FIELD REVISION SHEET
THIS SHEET SUPERSEDES SHEET 487

I-81 VIADUCT (COMMUNITY GRID) - CONTRACT 3
CITY OF SYRACUSE
OSWEGO BOULEVARD, SH C56-11
BEAR ST, SH C59-4
COUNTY: ONONDAGA REGION: 03

DRAINAGE AND UTILITY PLANS
N. CLINTON ST
AND GENANT DR

CONTRACT NUMBER D265218

DRAWING NO. DRP-29
SHEET NO. 556R2

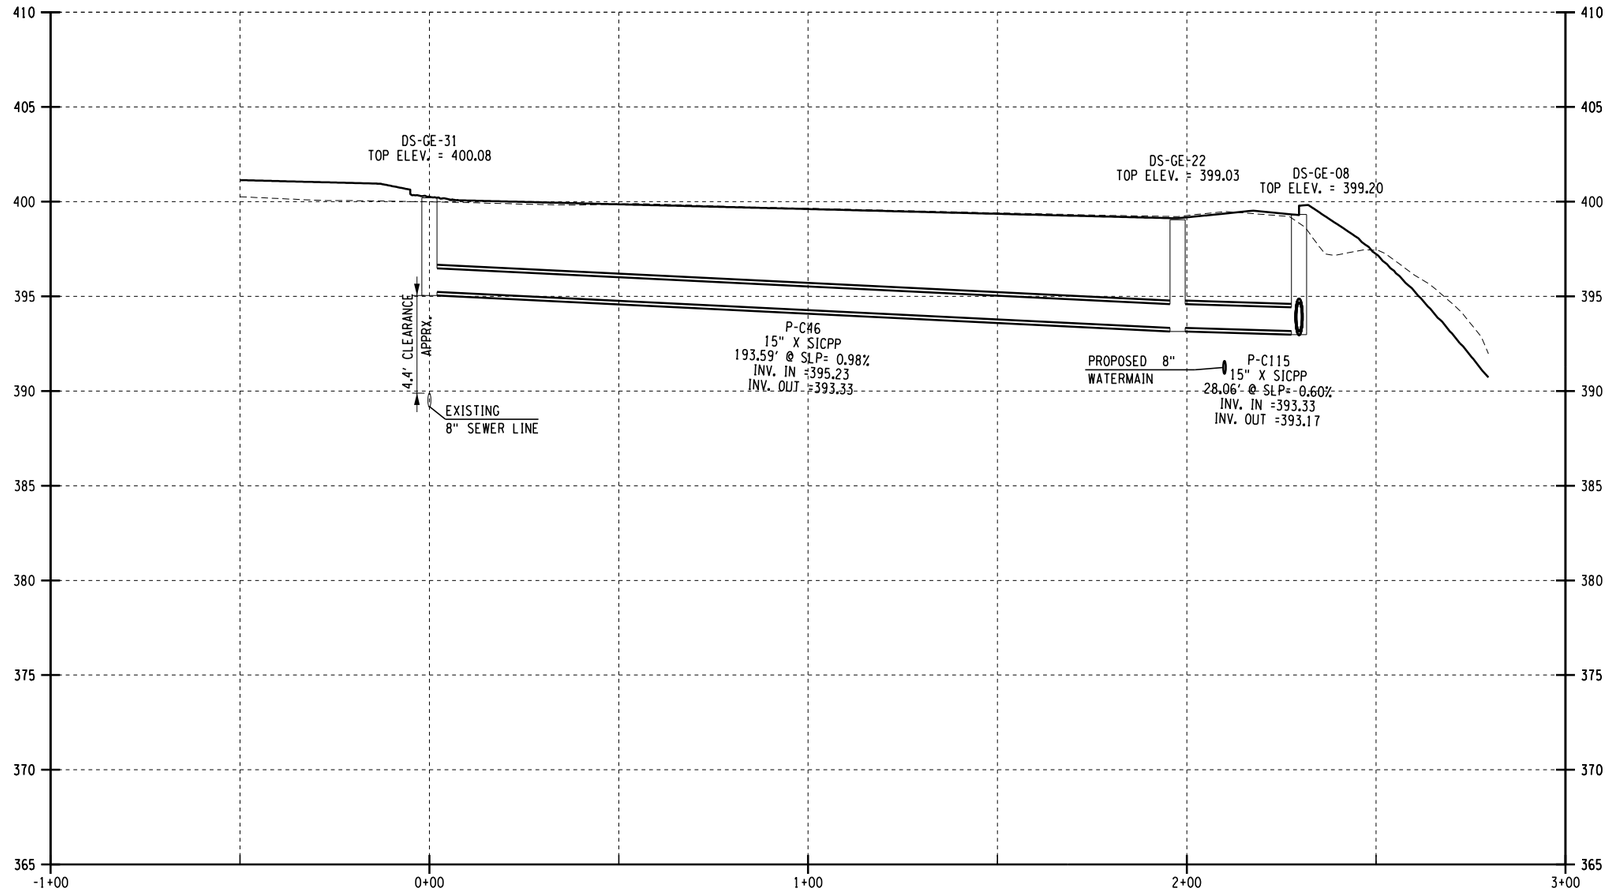
1. ADDED EXISTING SANITARY PIPE UNDER DS-GE-31.

DRAWING NO. DRP-39A
SHEET NO. 566R5

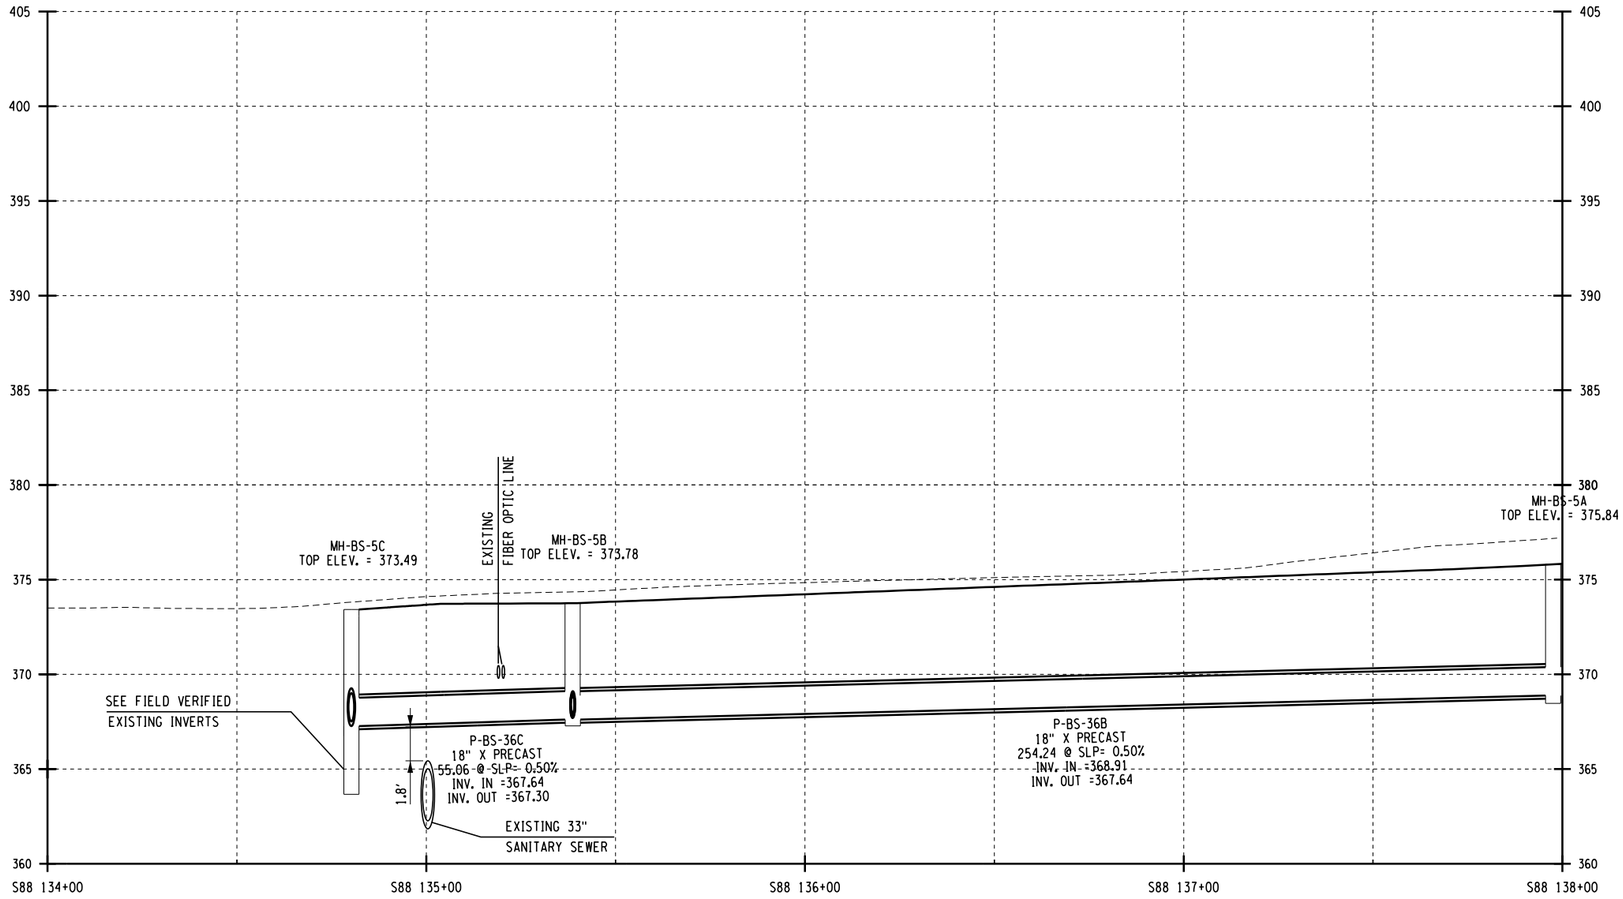
1. ADDED PIPES P-BS-36B, P-BS-36C, P-BS-5A AND P-BS-5B.
2. ADDED STRUCTURES MH-BS-5A, MH-BS-5B AND MH-BS-5C.

DRAWING NO. DRP-39
SHEET NO. 566R4

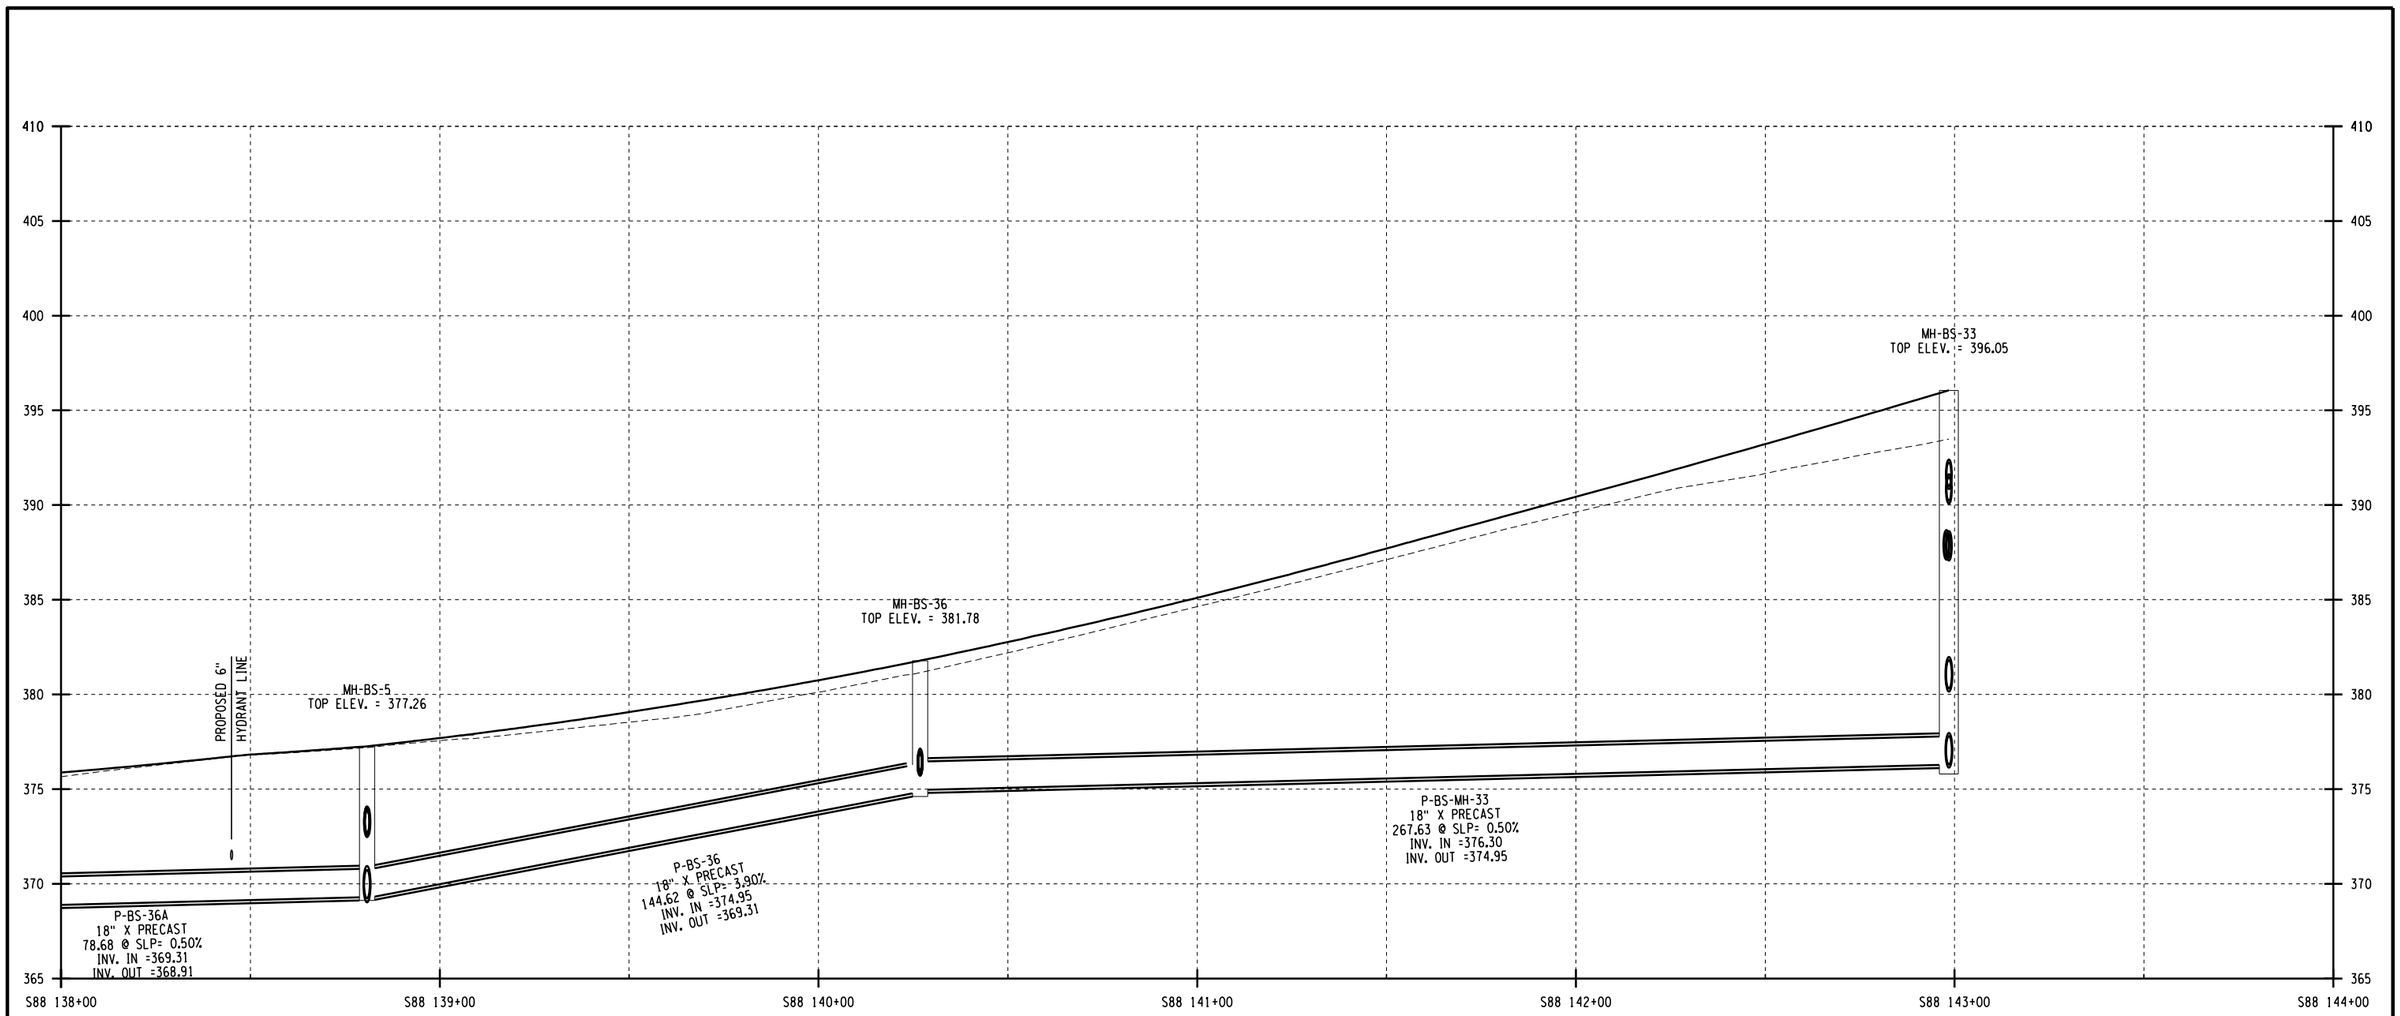
1. ADDED PIPE P-BS-36A.

DRAWING NO. DRP-46
SHEET NO. 573R2

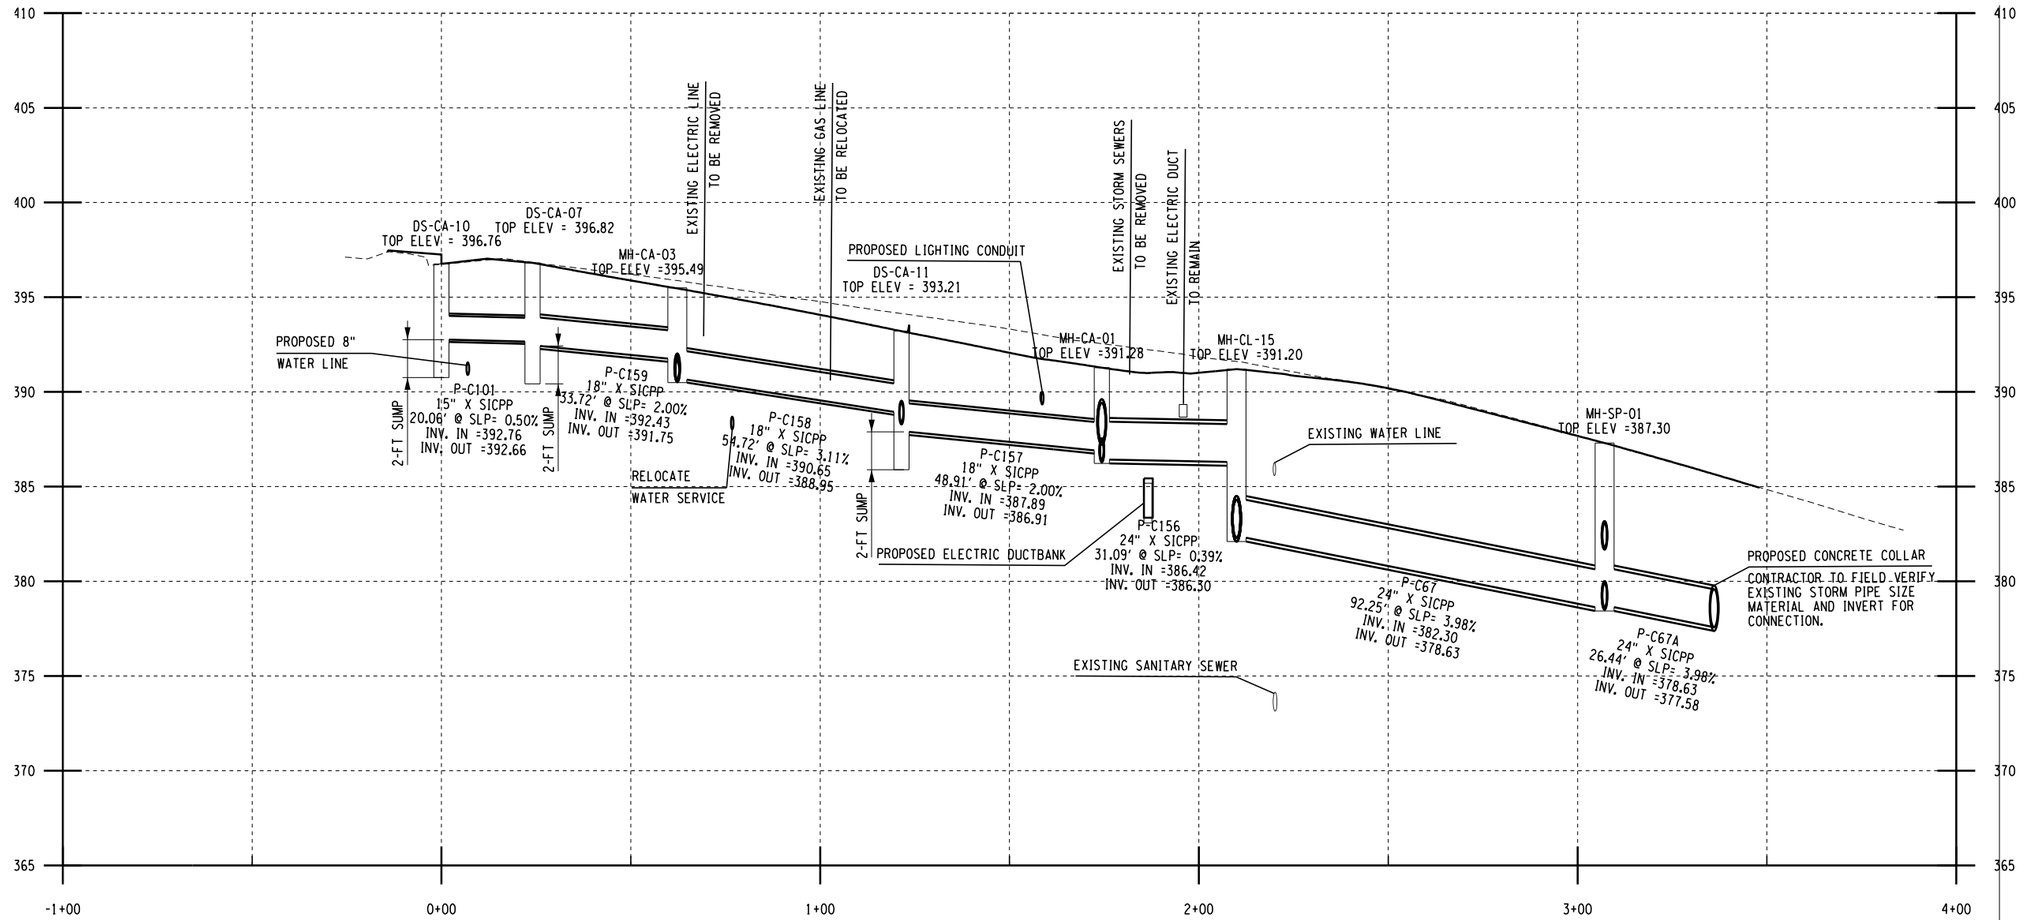
1. REVISED LENGTH FOR P-C159, P-C158, AND P-C157.
2. REVISED INVERTS AND SLOPE FOR P-C101.
3. REVISED DOWNSTREAM INVERT AND SLOPE FOR P-C158.
4. REVISED TOP ELEVATION OF DS-CA-11.
5. ADDED PIPE P-C67A.

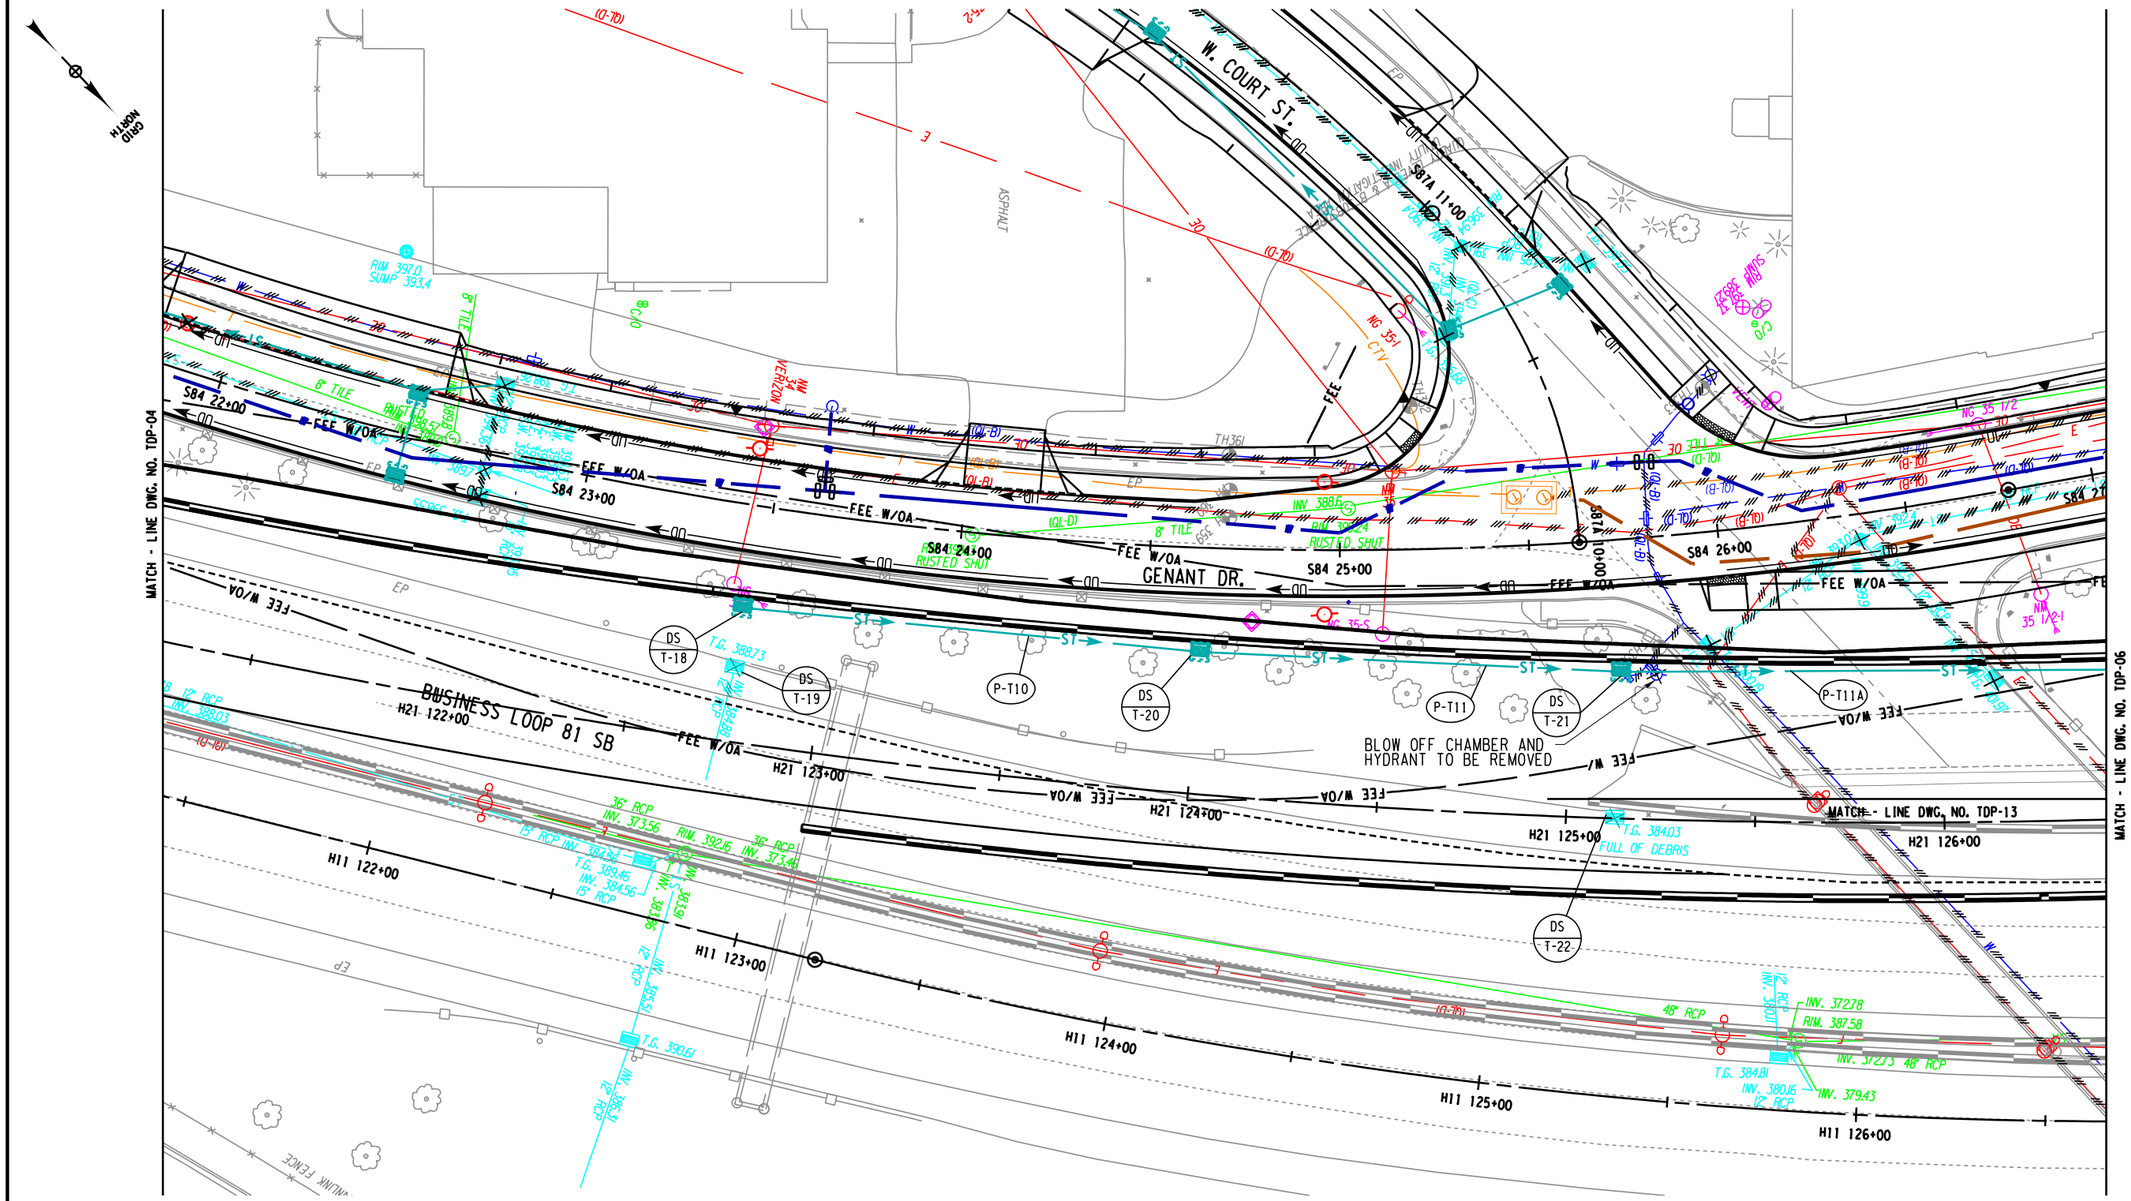
1. RELOCATED MANHOLE MH-T-3, DS-T-23 AND PIPE P-T12.
2. ADJUSTED P-T11A AND P-T13.
